Cuckoo's Nest, Greenhills Road, Kilnamanagh, Dublin 24

CFI Submission

Ref No. SD22A/0285

Please find landscape response to items (2 and 3a,3b,3c)

# CFI: Item 3 C (i)

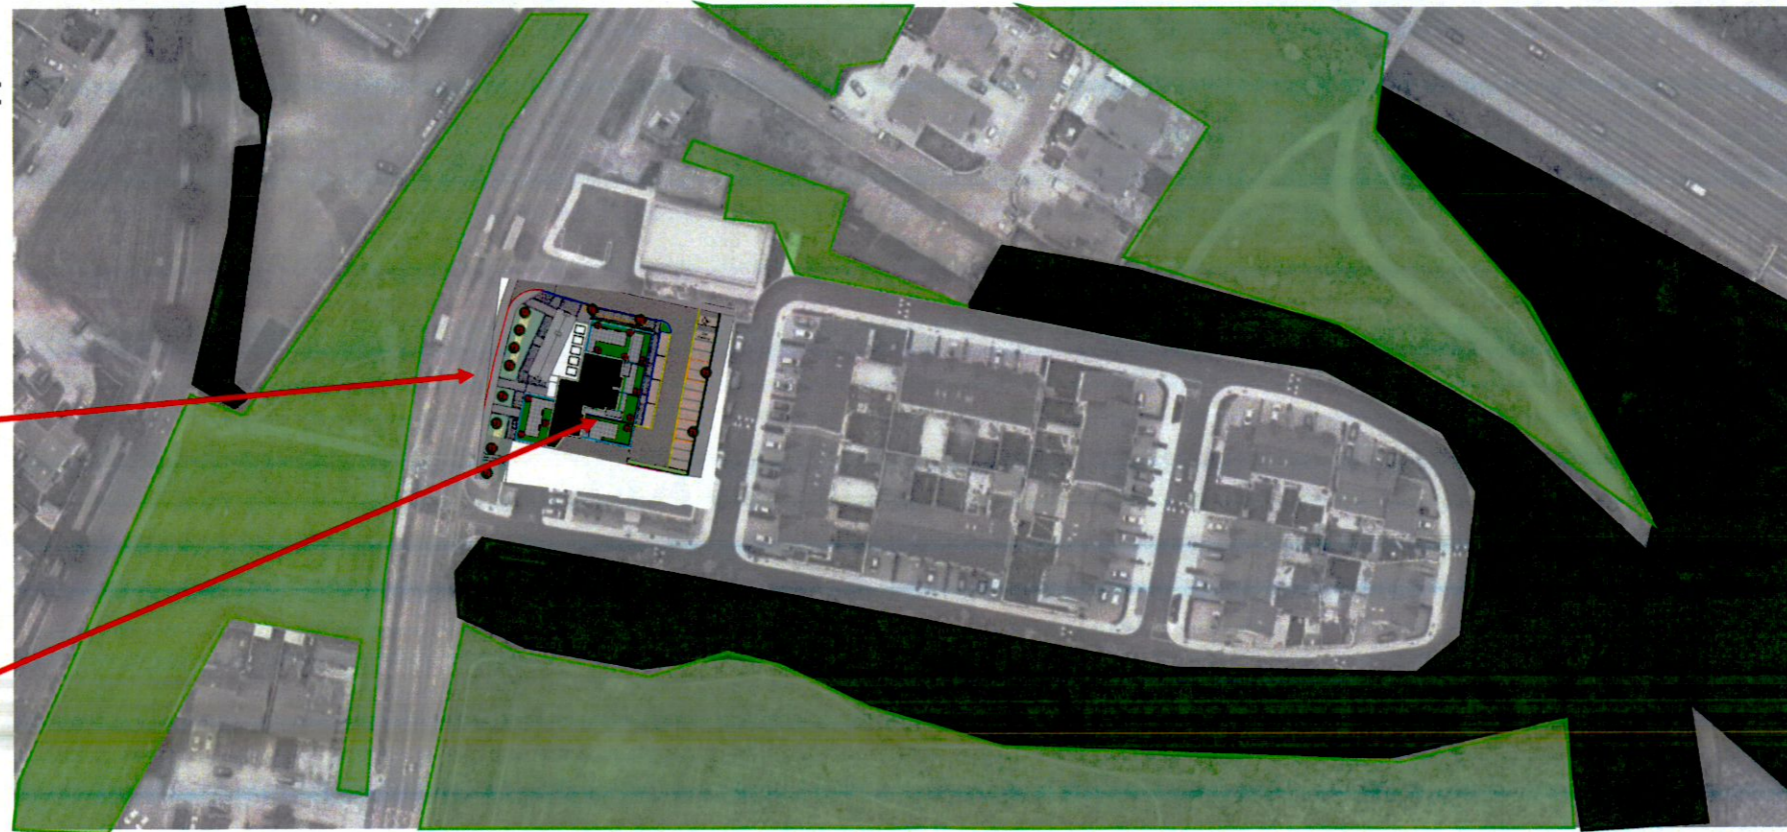
- C. In assessing the provision of SuDS at the site, the applicant shall consider the interrelationship of SuDS and green infrastructure. The applicant is required to show compliance with the quoted policies and sections of the South Dublin County Development Plan 2022 – 2028 and submit details demonstrating:
  - i. How they intend to reduce fragmentation of existing green infrastructure. The applicant should provide a green infrastructure plan showing connections through the site and connections to wider GI network.

(i). – The proposed site is on an infill site which currently has no real existing GI, in our design we have added tree planting, shrub planting, green roofs and open grass areas to try and reduce the fragmentation of the site to the areas around it. In this, a total landscape approach has been adopted. We have used green roofs, tree pits and green areas to try and connect the site better with a more concise design. All the landscape elements previously mentioned combine to provide SuDs in the site.

Current Site:

No GI connection crossing the road

Current site has no green infrastructure at all.

Proposed Site:

GI connection crossing the road. Grass verge and tree planting

Proposed site adding to the Gi with addition of tree planting, shrub planting, green roofs and grass areas

## CFI: Item 3c (i)

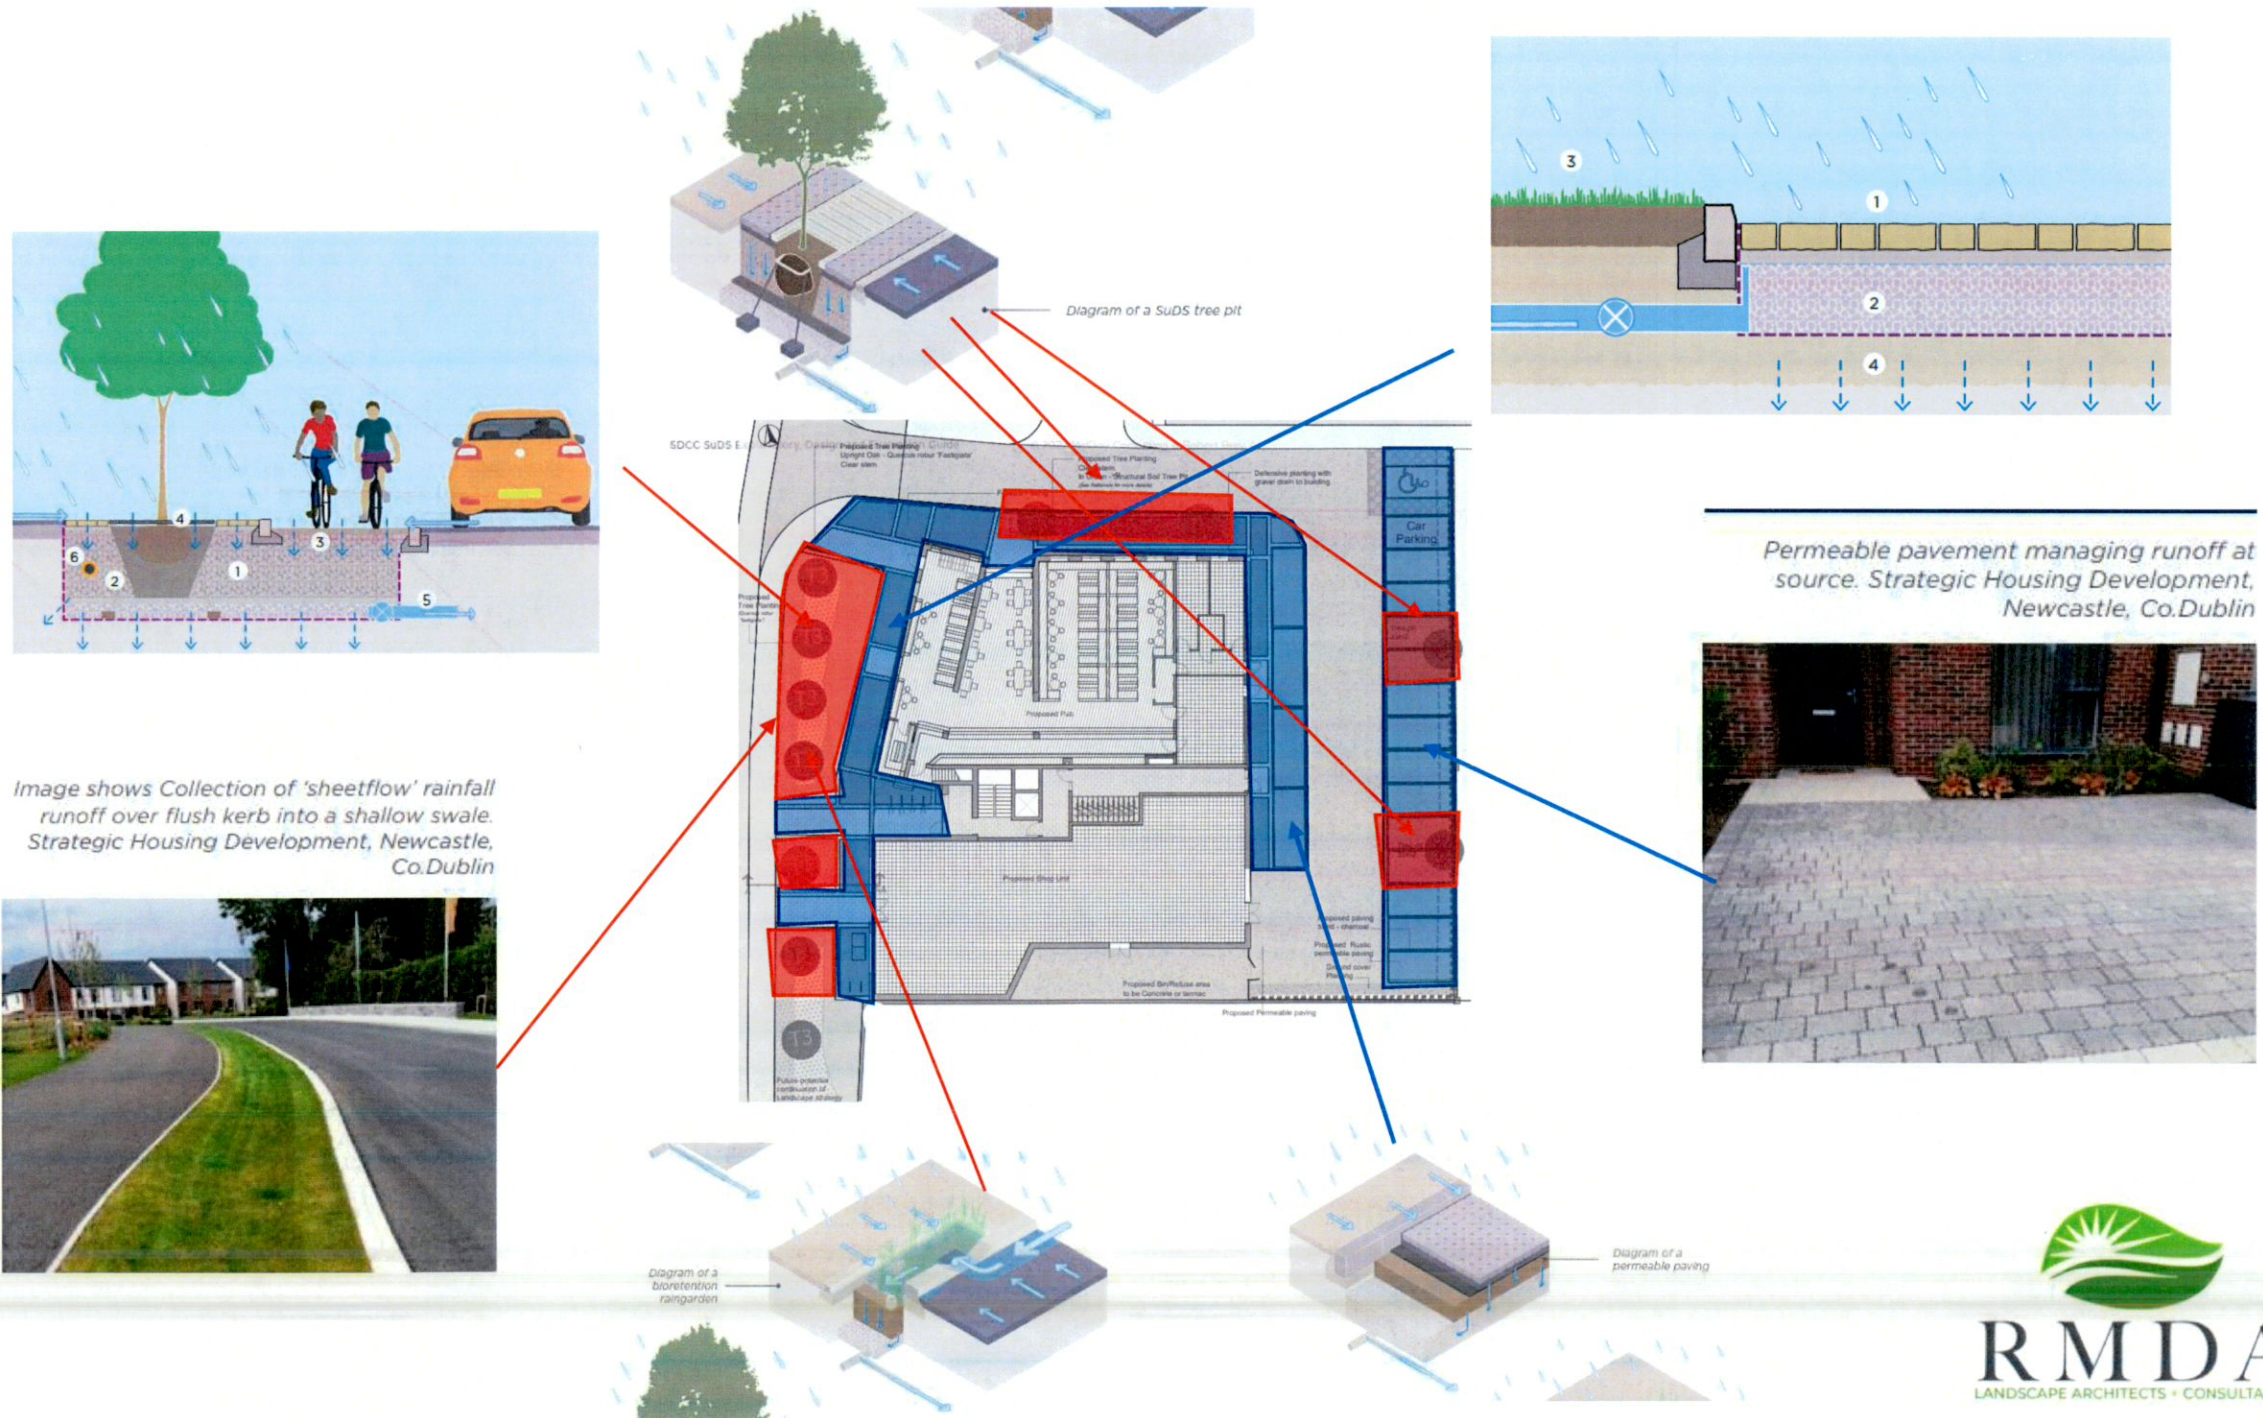
- C. In assessing the provision of SuDS at the site, the applicant shall consider the interrelationship of SuDS and green infrastructure. The applicant is required to show compliance with the quoted policies and sections of the South Dublin County Development Plan 2022 – 2028 and submit details demonstrating:
  - i. How they intend to reduce fragmentation of existing green infrastructure. The applicant should provide a green infrastructure plan showing connections through the site and connections to wider GI network.

The following images are taken from the SDCC SuDS plan and show how the site has incorporated SuDS and GI.

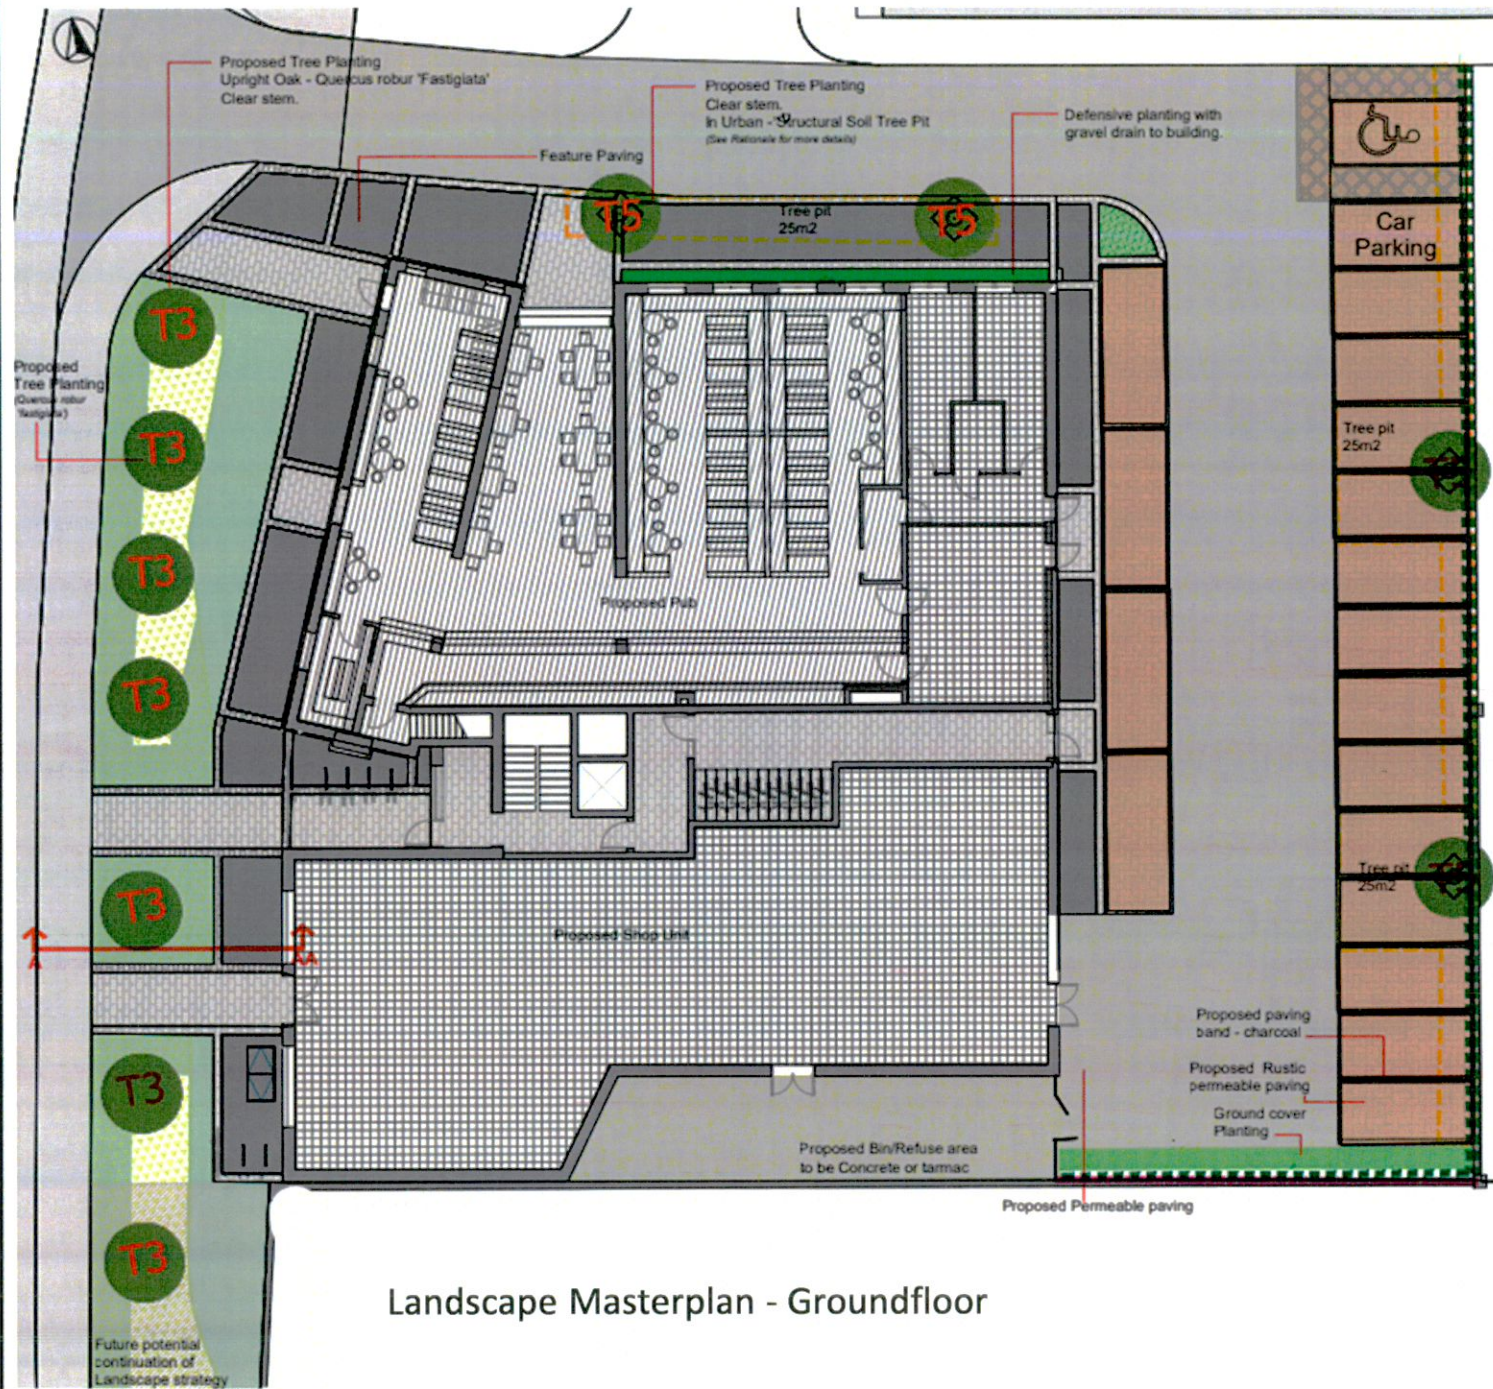
- C. In assessing the provision of SuDS at the site, the applicant shall consider the interrelationship of SuDS and green infrastructure. The applicant is required to show compliance with the quoted policies and sections of the South Dublin County Development Plan 2022 – 2028 and submit details demonstrating:
- ii. How the appropriate Green Space Factor (GSF) will be achieved for the relevant land use zoning objective.

(ii) - We have calculated the green space factor, however as a small infill site, the GSF is difficult to achieve as the original open space has been taken in charge.

The site has been maximised to the current location. Originally the development was part of a larger development to the rear with the correct quantum of open space met. The current application is being viewed as a separate application hence the requirements for green open space. We have been in consultation with SDCC Public Realm / Parks department in relation to the GI Score.

We have been advised by Parks department that the upgrades to Tymon Park shall satisfy the balance of the GI score.
